UNITED STATES NUCLEAR REGULATORY COMMISSION WASHINGTON, D. C. 20555

SAFETY EVALUATION BY THE OFFICE OF NUCLEAR REACTOR REGULATION ON THE ACCEPTABILITY OF THE ANALYTICAL MODEL FOR PREDICTING VALVE.DYNAMICS

Figure 2 Steps in determining plant unique vacuum breaker - forcing functions

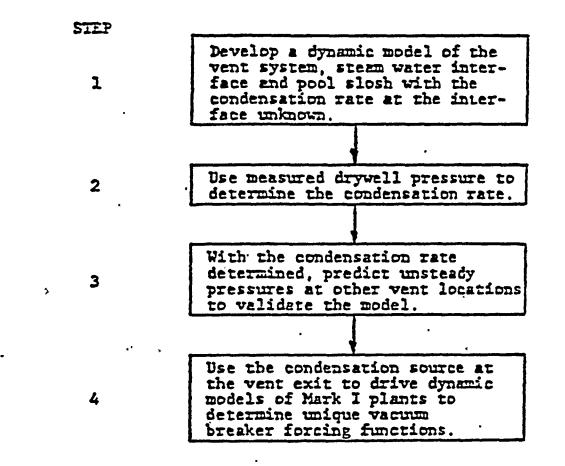
histories from the FSTF test facility. After transferring these condensation sources to a model of an actual Mark I plant, the analytical model would compute the pressure time history across the disk of the vacuum breaker. Figure 2, extracted from CDI report 84-3, provides the steps followed to determine the plant unique vacuum breaker forcing functions.
